Environmental Minor Project Refinement Form

Project Name: West of Devers Upgrade Project Request Prepared By: Sylvia Granados

Date Approval Required: August 23, 2021 Variance Request No.: 50

Southern California Edison
West of Devers Upgrade Project
Work Area
MPR #50

FIGURE 1
Page 1

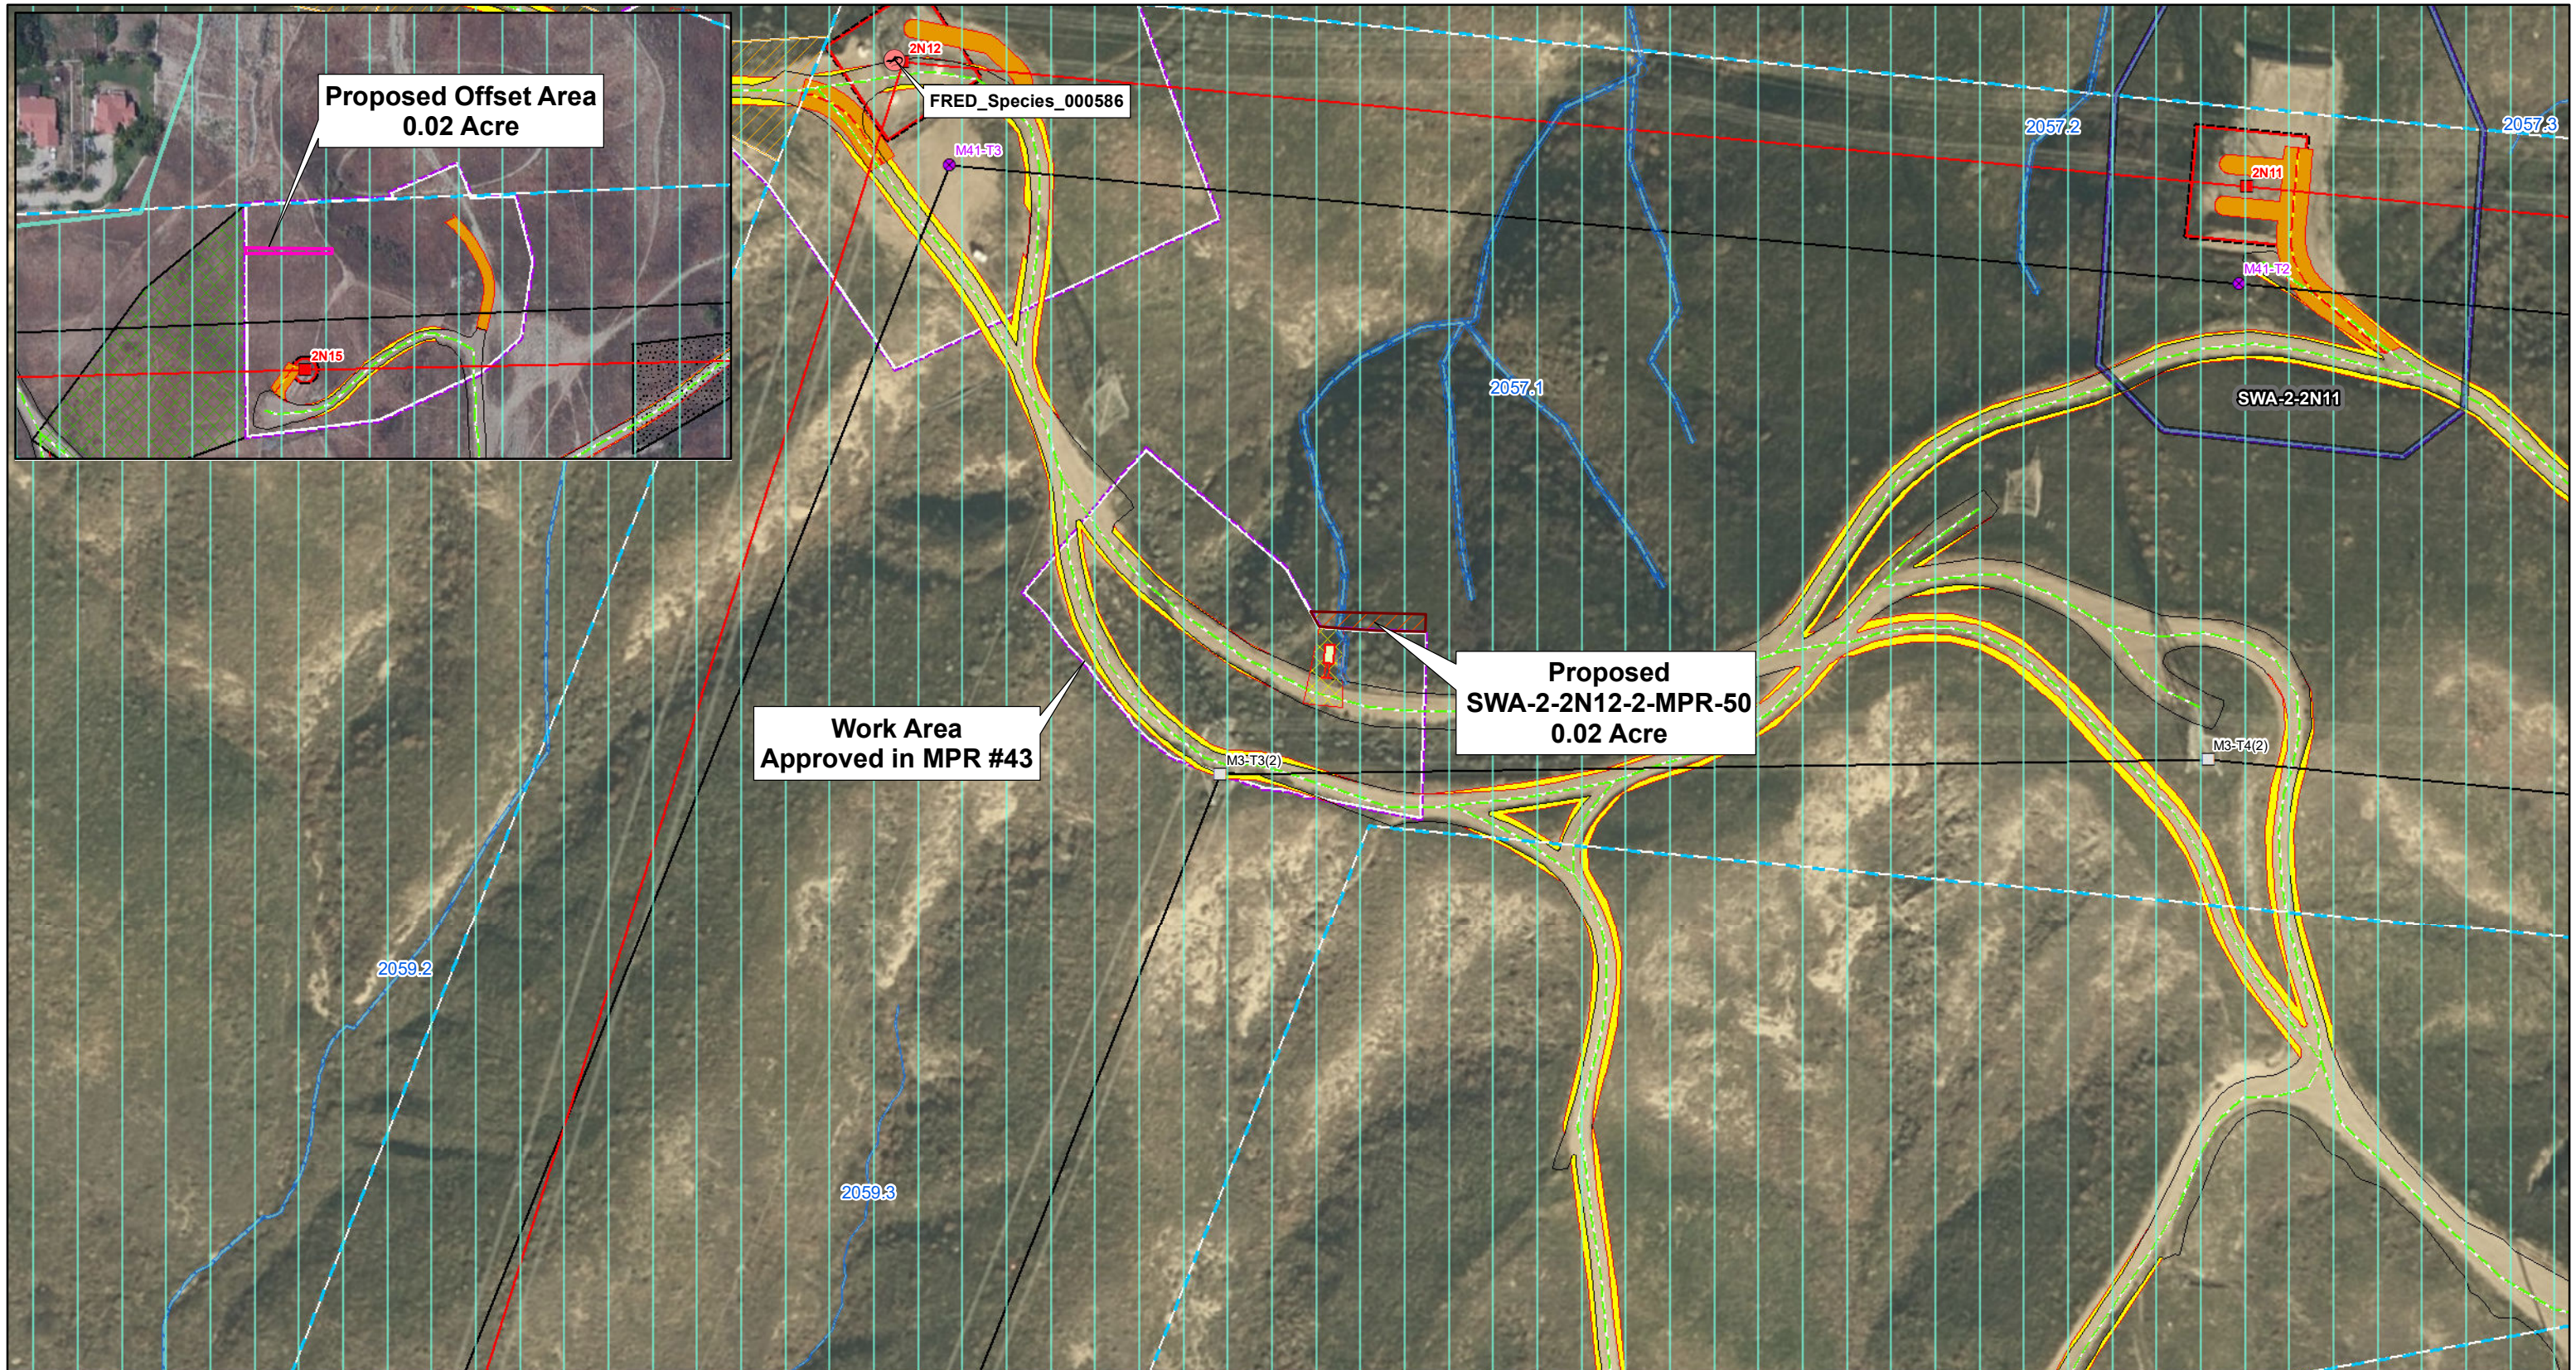
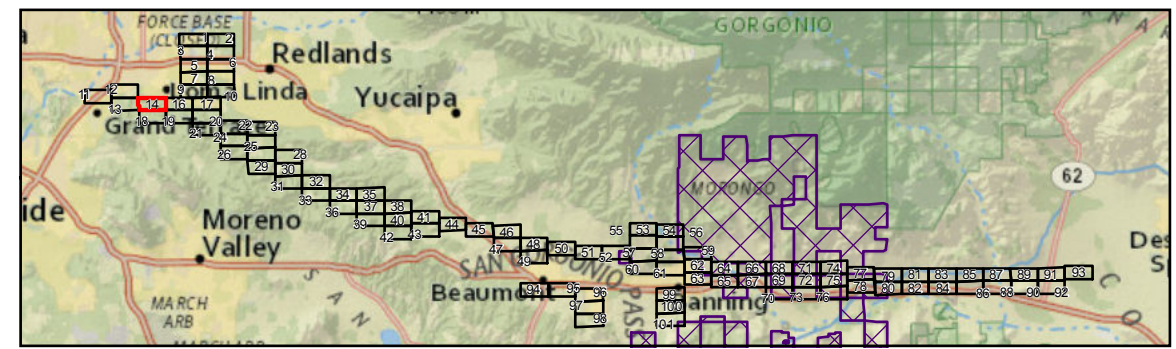
The grading limit, previously approved in MPR #43, will be expanded north of SWA-2-2N12-2-MPR-43 to provide 0.02-acre of temporary work space to McCarthy Drain work limit MWL-2-SE-2N12-1, to facilitate the installation of the McCarthy drain, as shown in Figure 1, page 1. The expanded work area will be used to safely stage material, equipment, and personnel during the installation.

To offset additional impacts to Critical Habitat subject to mitigation in the new 0.02-acre work area, the area shown in the detail of Figure 1, page 1, north of 2N15 (also located in critical CAGN habitat), will not be used for construction. The offset area will be removed from the project data upon approval of this MPR.

The new temporary impacts to the jurisdictional water feature associated with MPR 50 expansion area SWA-2-2X12-2-MPR-50 are 51.53 square feet. The LSAA, 404 NWP, and 401 WQC have been amended to permit the new impacts shown in Figure 1, page 1. Therefore, no additional non-permitted impacts to jurisdictional features are anticipated.

Figure 3 Sheet 14
Southern California Edison - West of Devers Upgrade Project
CDFW Jurisdictional Waters Impact Maps

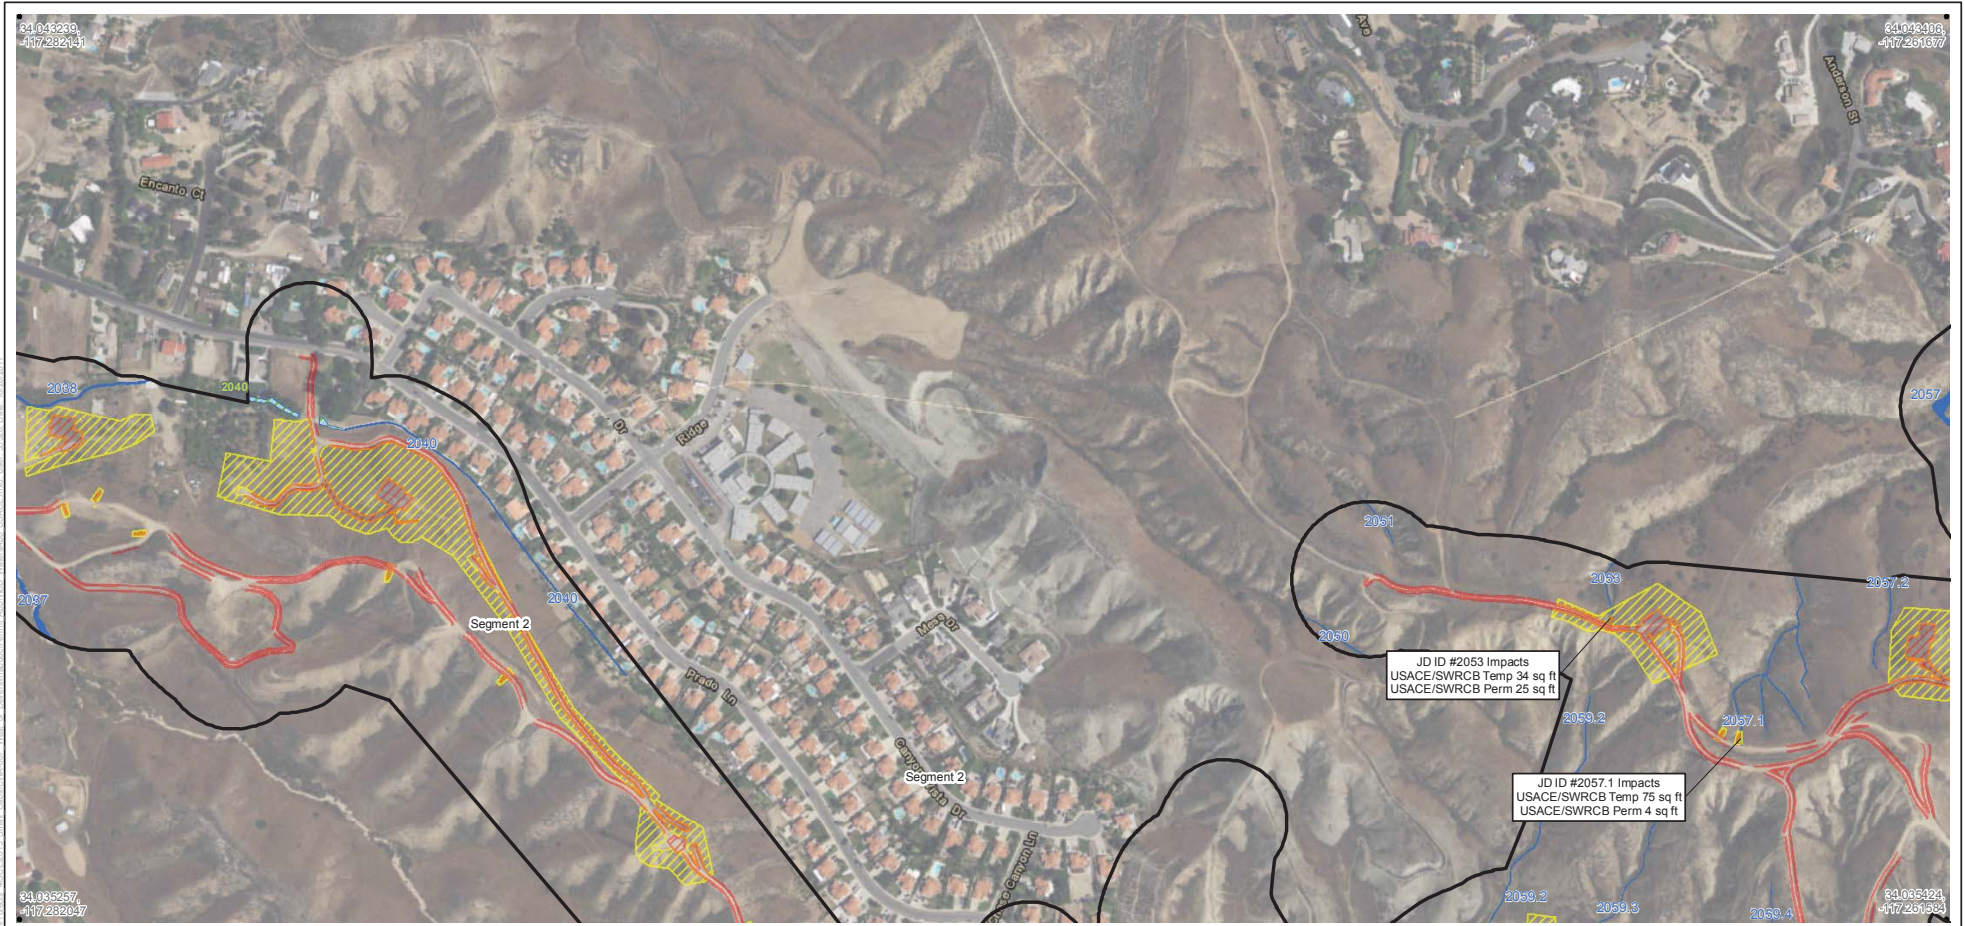
Non-wetland feature 2057.1 intersects SWA-2-2X12-2-MPR-50, as shown in Figure 1, page 1. Figure 2 illustrates that 168 square feet of temporary impacts and 12 square feet of permanent impacts are permitted by CDFW in the 1602 LSAA for this water feature. Figure 3 illustrates that 75 square feet of temporary impacts and 4 square feet of permanent impacts are permitted by USACE in the 404 NWP for this water feature. The location and size of this McCarthy drain have not changed since it was originally designed and permitted.
